41 LaGrange Street  
January 16, 2019

## Comments from December 4, 2018 BCDC meeting

41 LaGrange Street

SECTION A

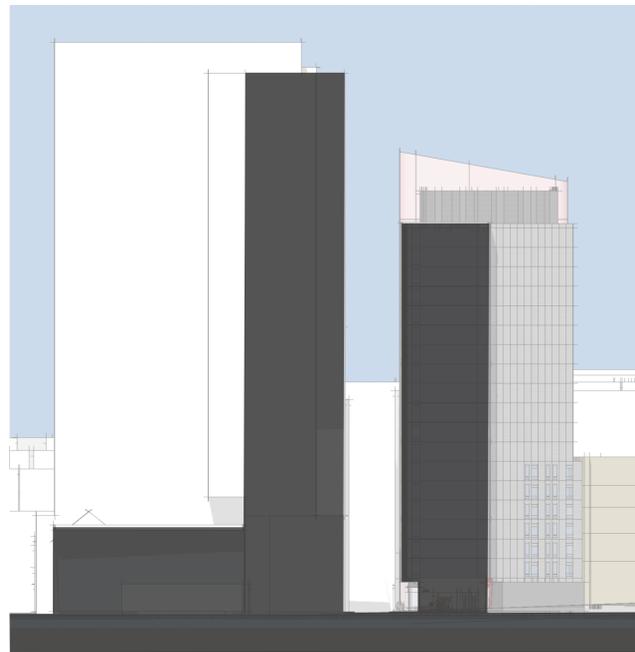
- Need to better understand the pedestrian character of LaGrange Street
- Provide sections through LaGrange Street

Reviewed / revised detail at adjacent buildings

Revised alignment of facade accent banding

Revised relationship between ground floor and floors above

SECTION B

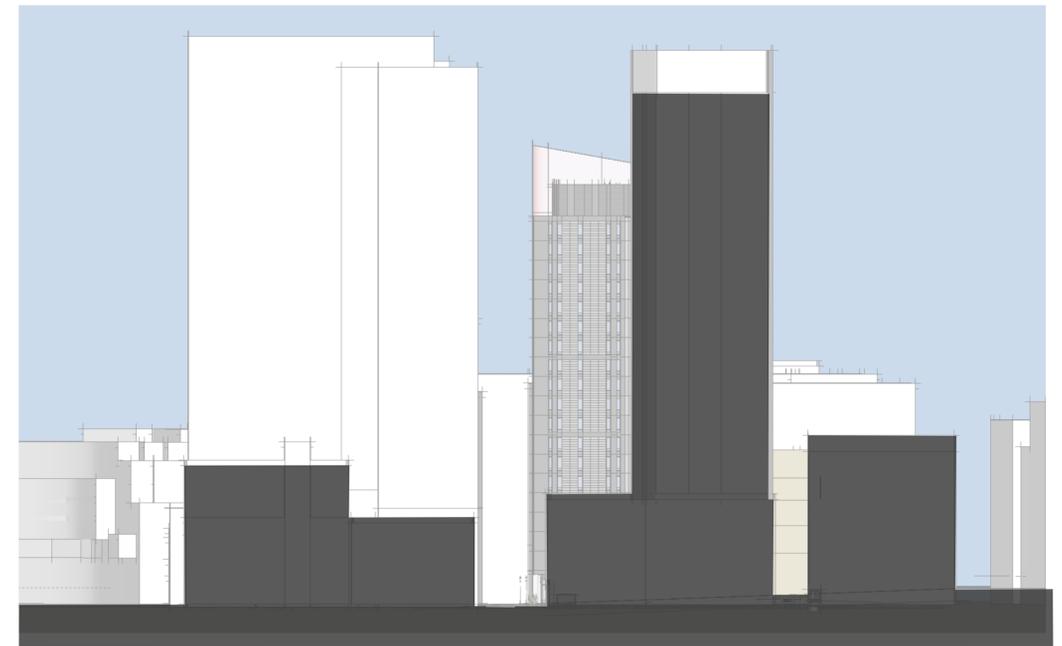
- Need to better understand the pedestrian character of LaGrange Street
- Review relationship of the ground floor facade to the floors above
- Concern for "hiding places" along ground floor facade

Ground floor recessed were reviewed - both include glass corners, active interior programming, increased lighting

Reviewed / revised detail at adjacent buildings

SECTION C

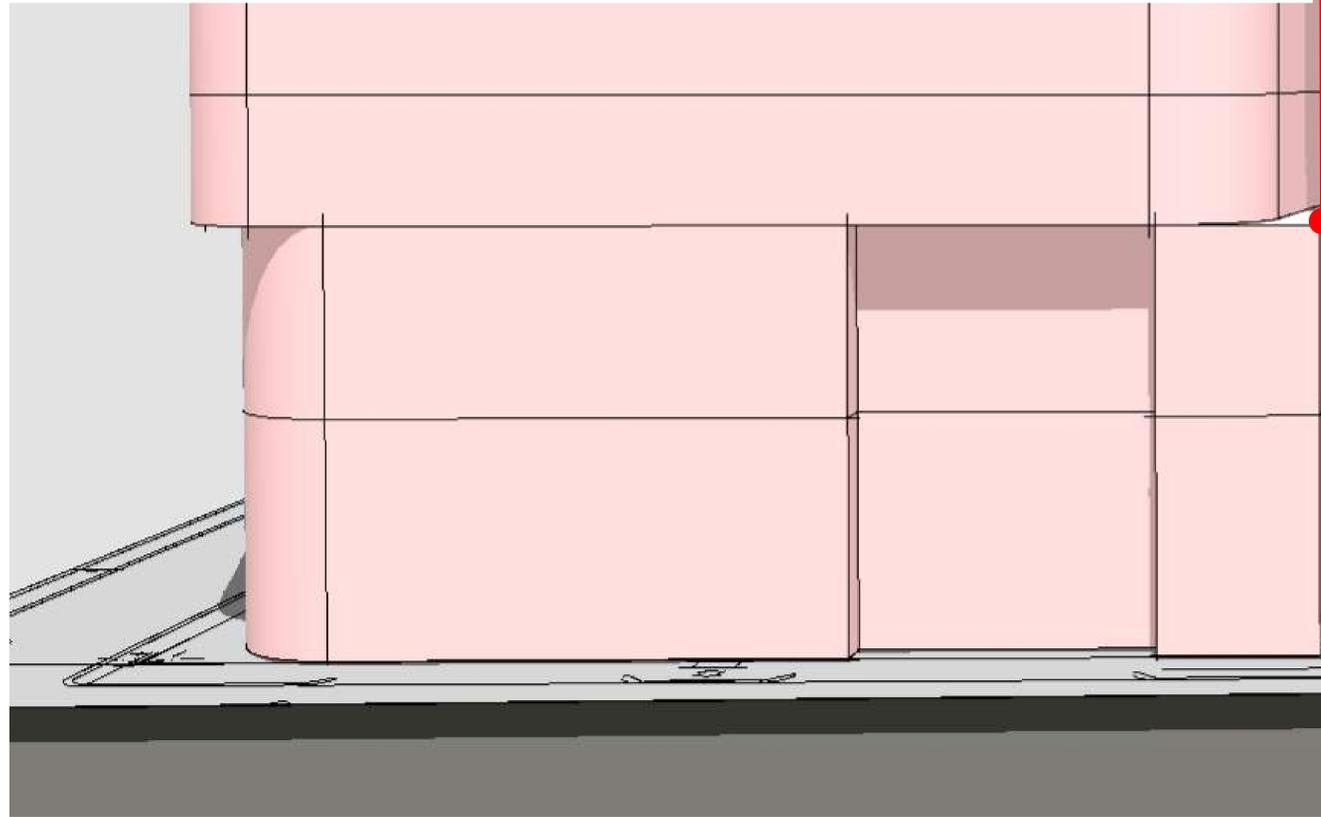
- Need to better understand the pedestrian character of LaGrange Street
- Concern for "hiding places" along ground floor facade

Ground floor recesses were reviewed - both include glass corners, active interior programming, increased lighting

Typical Floors 2-7

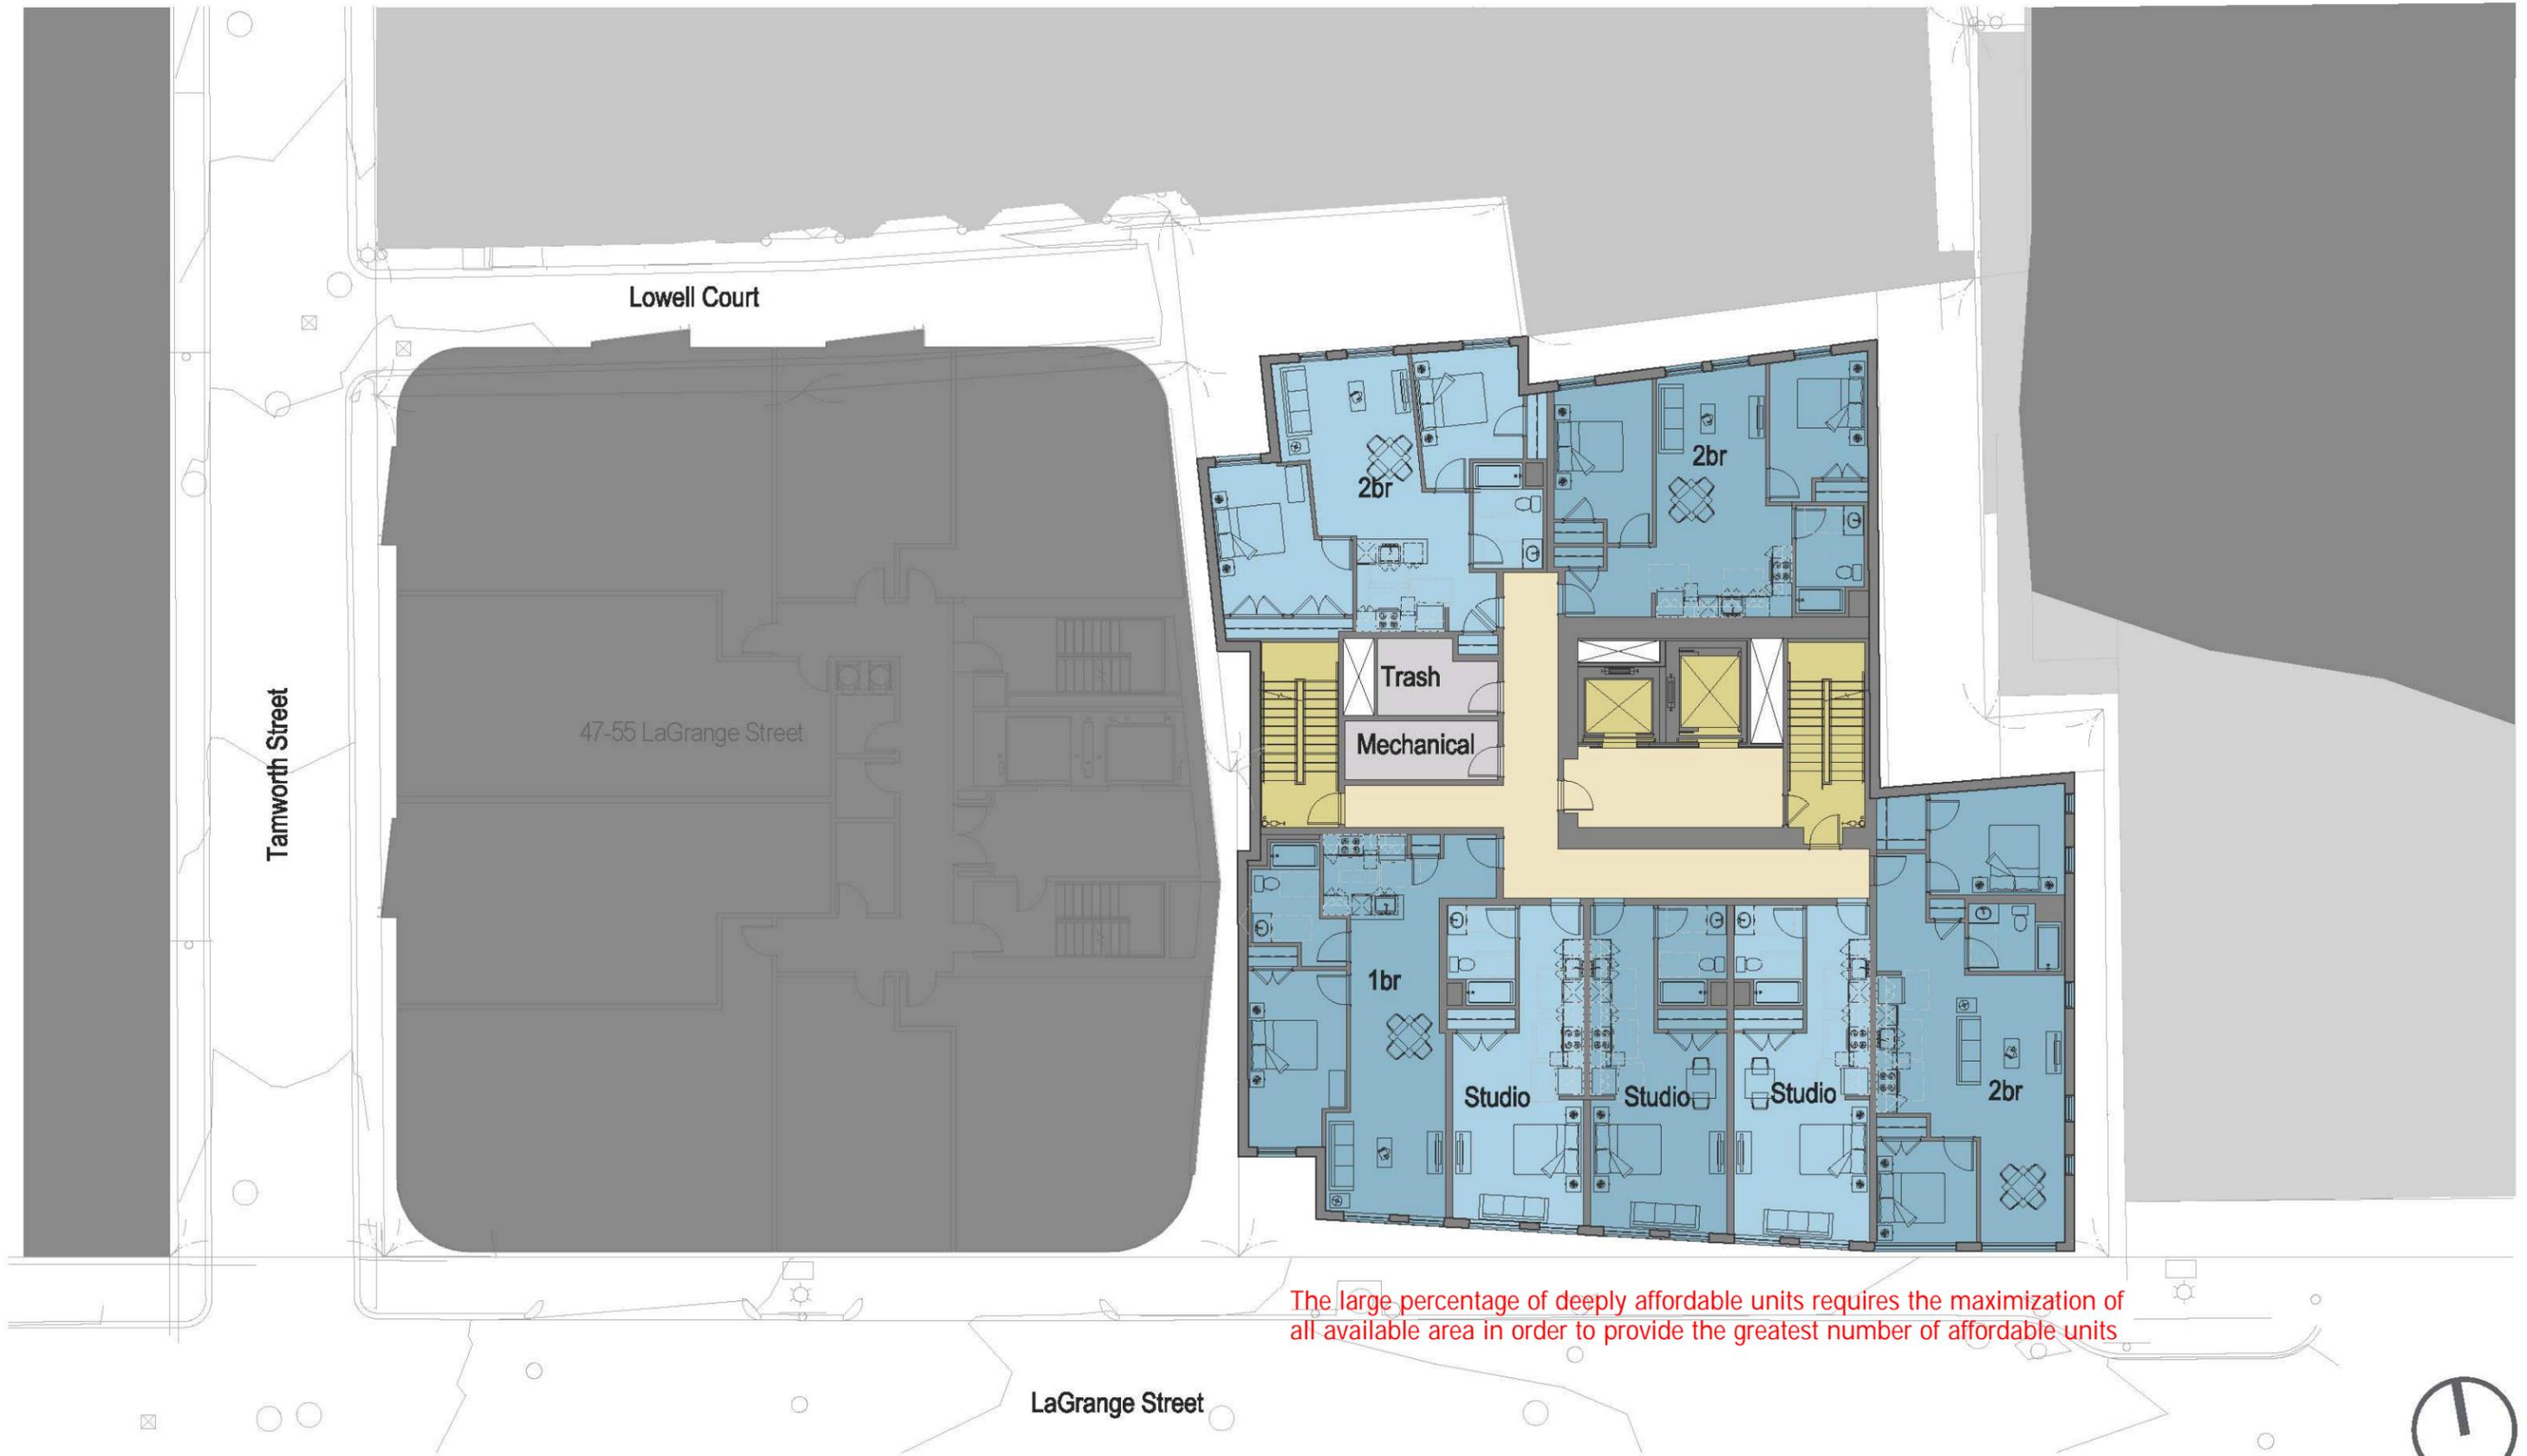
- Floor plate is challenging due to maximizing the available area

**Typical Floors 8-19**

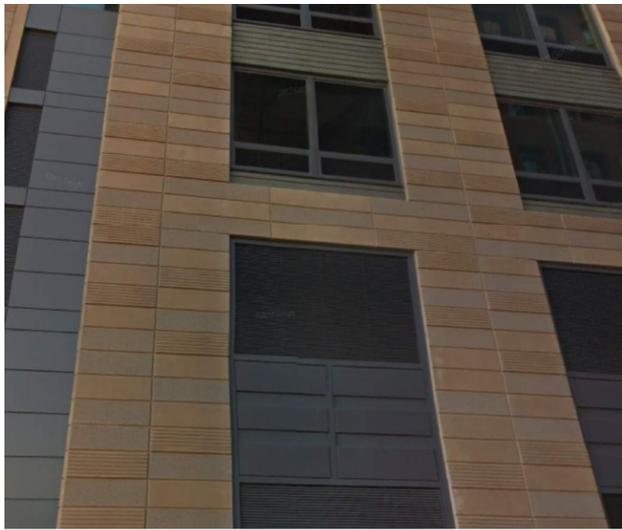
- Floor plate is challenging due to maximizing the available area
